From: Novak <nn@airkiosk.com>
Sent: Wednesday, November 15, 2023 3:02 PM
To: *City Council*; Dianne Boisvert
Subject: Remarks regarding proposed zoning changes for the former Global Gas station property
Attachments: Global current.pdf

I write to express my concerns about the proposed zoning changes and Development Agreement for the redevelopment of the former Mobil Gas Station property at State Street and High Street.

Global dev version 3+1 bird-eye view

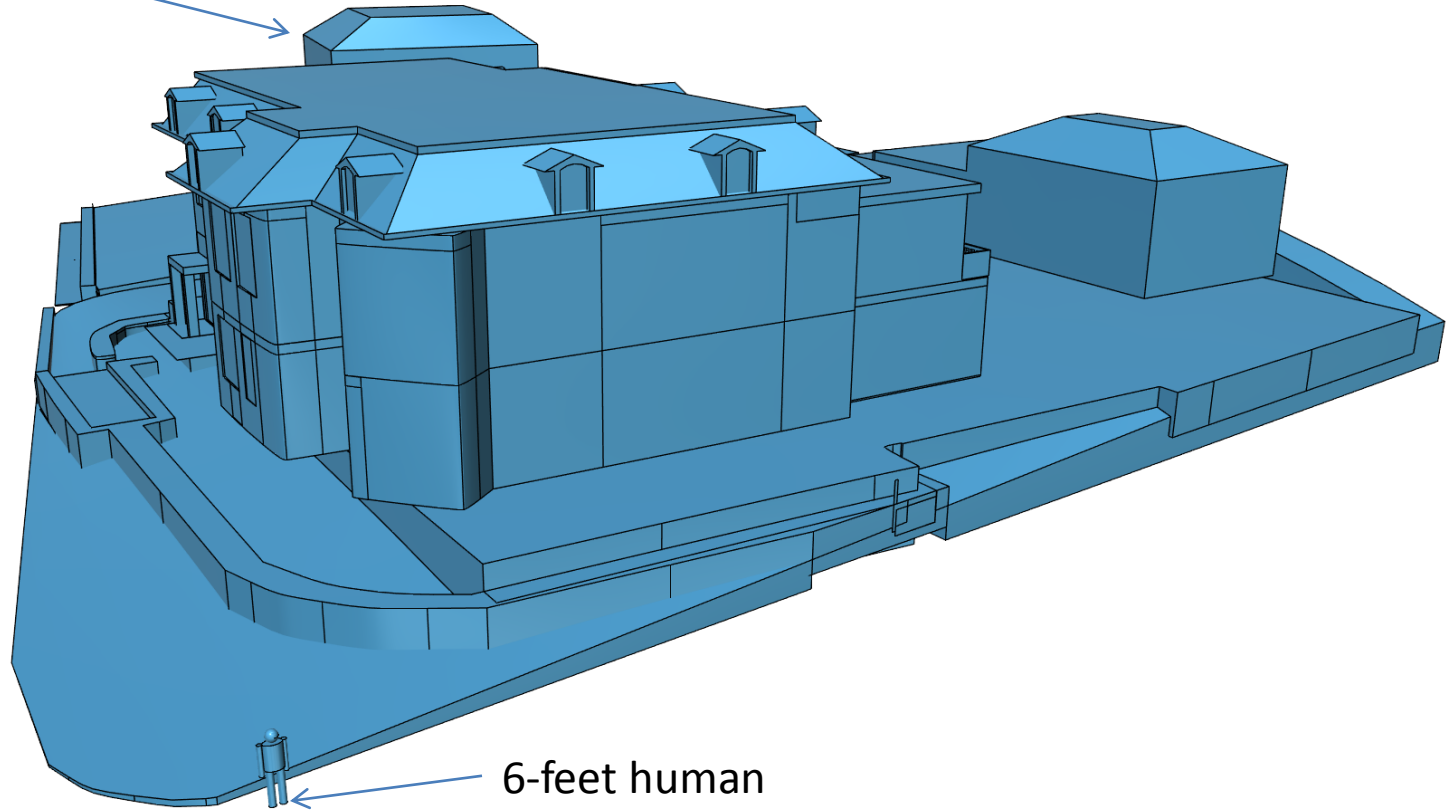
[I also rendered a 3D model of the development as included in the development agreement, hereby attached.]

Global dev 93 High property line retaining walls

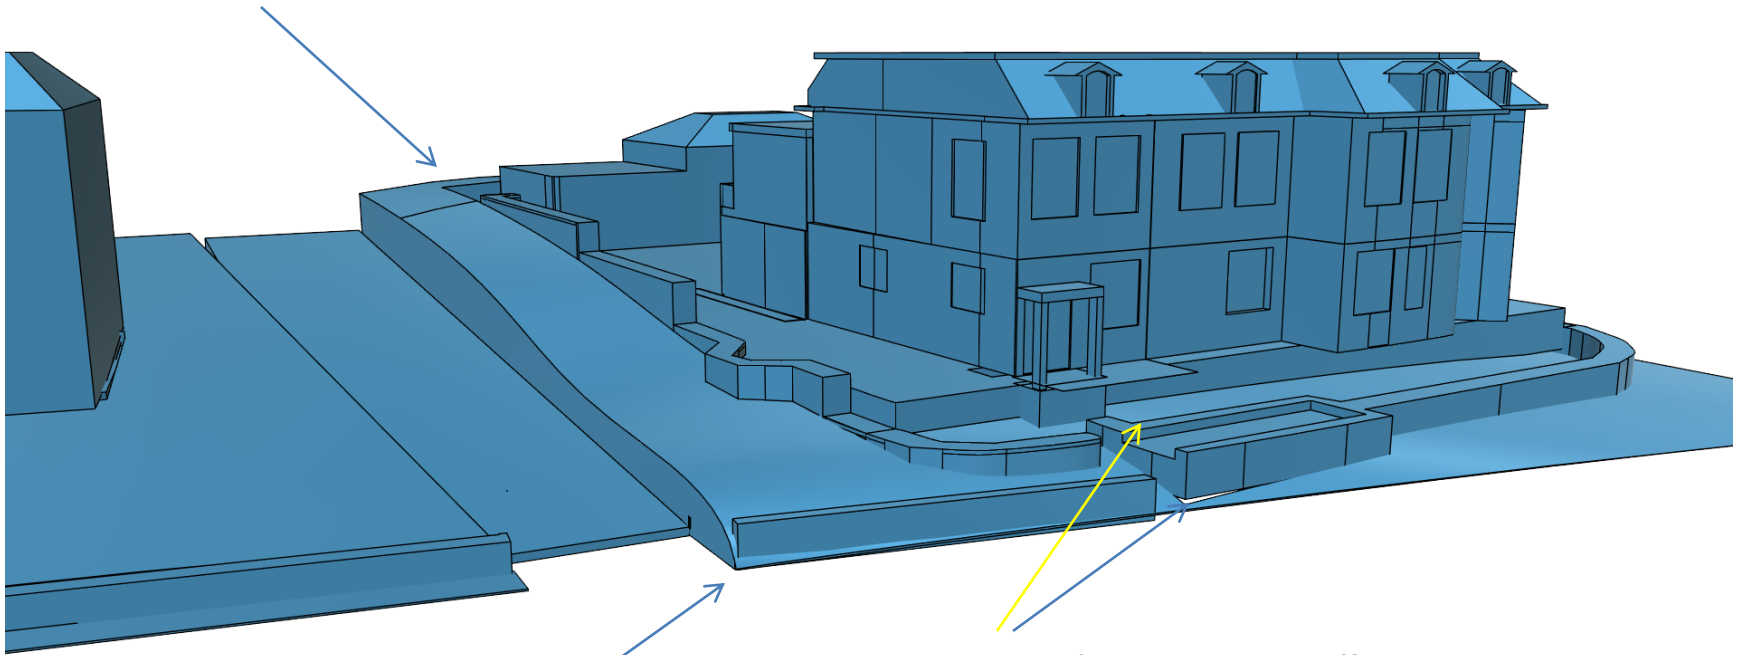
Cascading retaining walls between the properties

Terraced retaining walls

Retaining walls stretching to the driveway
